Technical Service Information

THM 4L80-E NEW DESIGN MANUAL 2ND BAND

Figure 1

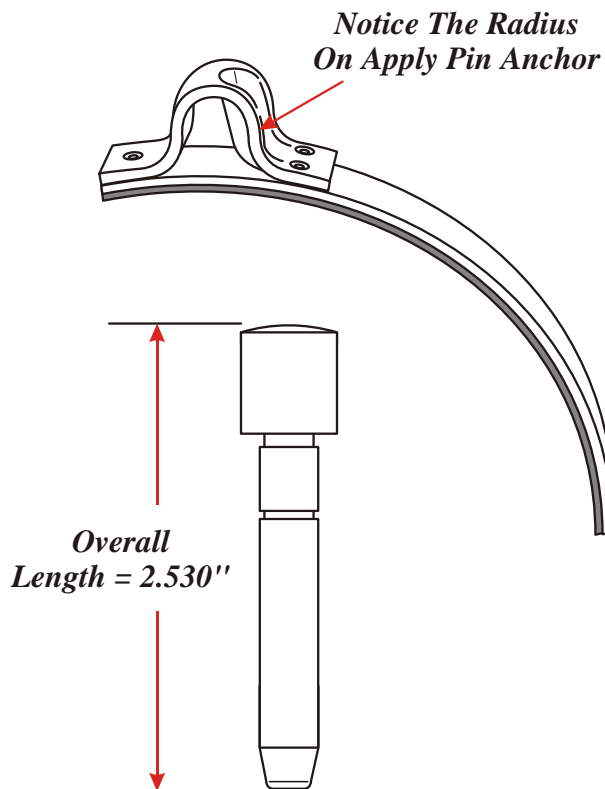
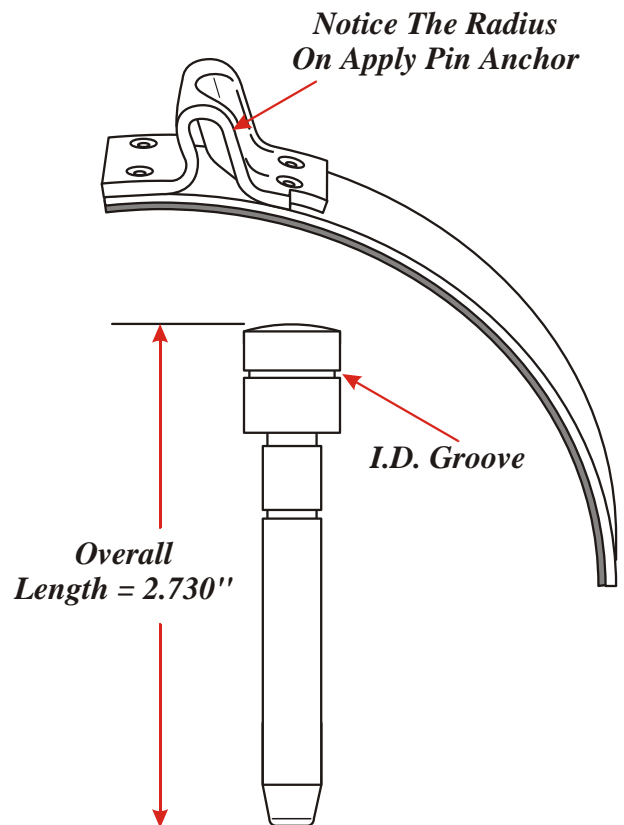
CHANGE: Beginning at the start of production for 1999 models, all THM 4L80-E transmissions were built with a revised manual 2nd band that is wider than the previous design (See Figure 1).

Figure 2

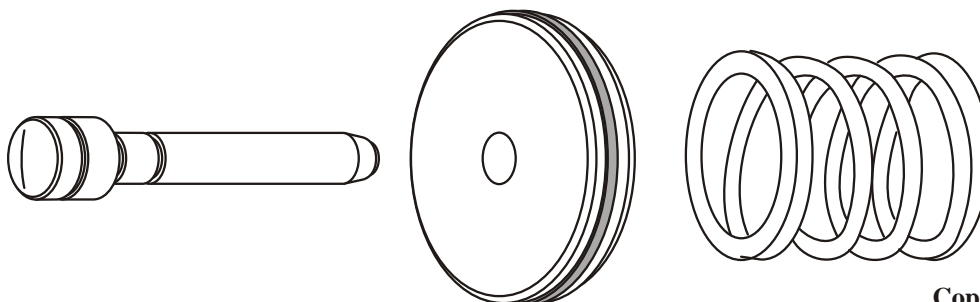
- (1) MANUAL 2ND BAND - Now 1-1/4 inches wide instead of the previous 1 inch wide, and manufactured with a revised band apply pin anchor, as illustrated in Figure 2.
- (2) MANUAL 2ND BAND APPLY PIN - The band apply pin has a revised overall length, 2.730" instead of the previous 2.530", to accommodate the revised apply pin anchor, as illustrated in Figure 2.

The new design "Wide Band" will retro-fit back, but you must purchase the new design band apply pin that is .200" longer than the previous design. Currently, it is only available in a service package that includes the piston and the return spring, under part number 24223081, as shown in Figure 2.

If the "Wide Band" is used with the Narrow Band Apply Pin, the result will be No Engine Braking when selector lever is moved to the Manual 2nd position, because the apply pin is not long enough to apply the band.

If the "Narrow Band" is used with the Wide Band Apply Pin, the result will be 2nd Gear Starts and tie-up on the 2-3 shift and tie-up in reverse, because you have mechanically applied the band because of the length of the pin.
